Planning & Zoning

PERMIT NUMBER:

#23-6183

ADDRESS: 4094 Domnall Drive

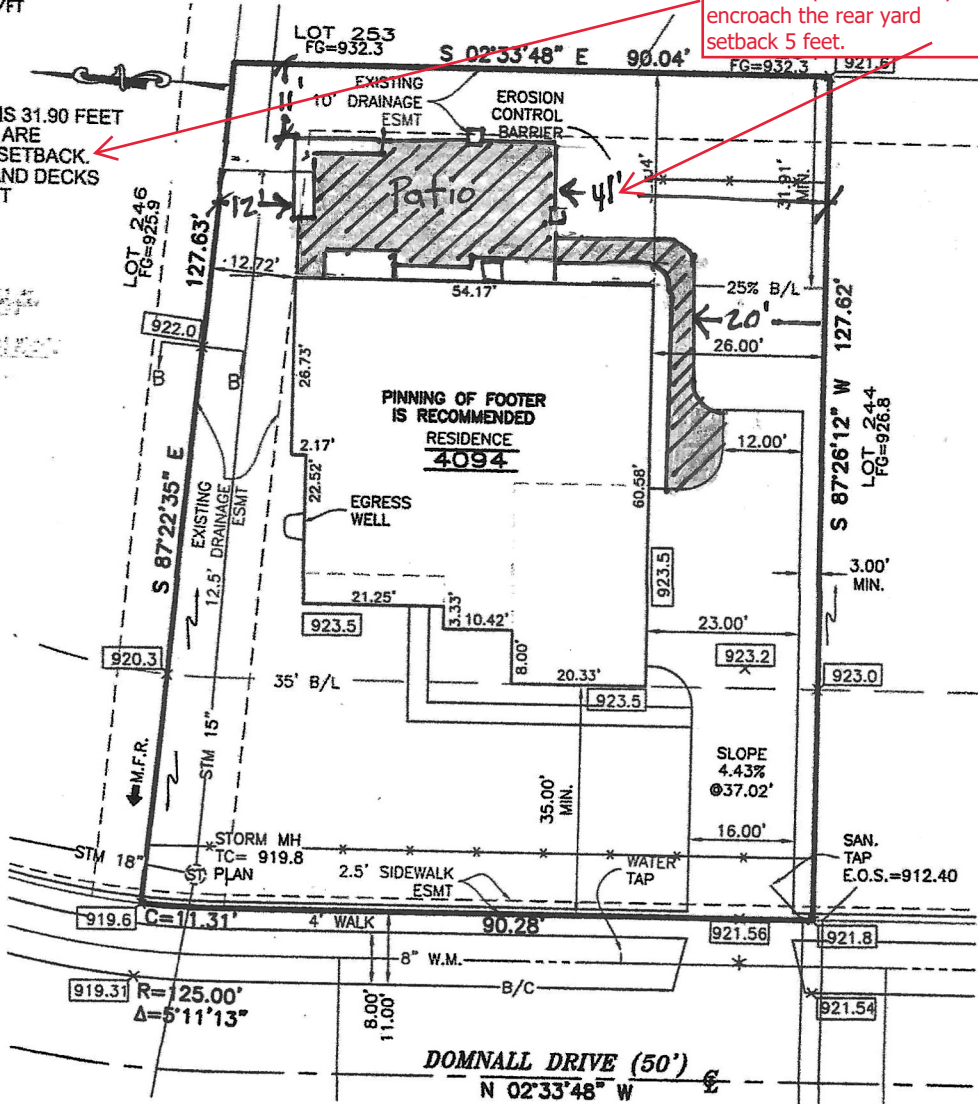
- **The provided plans are not accurately drawn to scale.**
 - See the attached document on pages 2 and 3 for a visual representation.
- **Rear yard setback of 31.90 feet. Uncovered patios and decks may encroach 5 feet.**
 - Plans show 21 feet into rear of the property which exceeds the allowable encroachment.
- **Please revise the materials and email all revisions to the reviewer mentioned above: jthenderson@dublin.oh.us**

Uncovered patios can only encroach the rear yard setback 5 feet.

REAR YARD SETBACK IS 31.90 FEET
 NO ENCROACHMENTS ARE PERMITTED INTO THE SETBACK.
 UNCOVERED PATIOS AND DECKS MAY ENCROACH 5 FEET

21' in depth will be exceeding the limit of the rear yard setback. The 21' would also encroach the 10' drainage easement at the rear of the property.
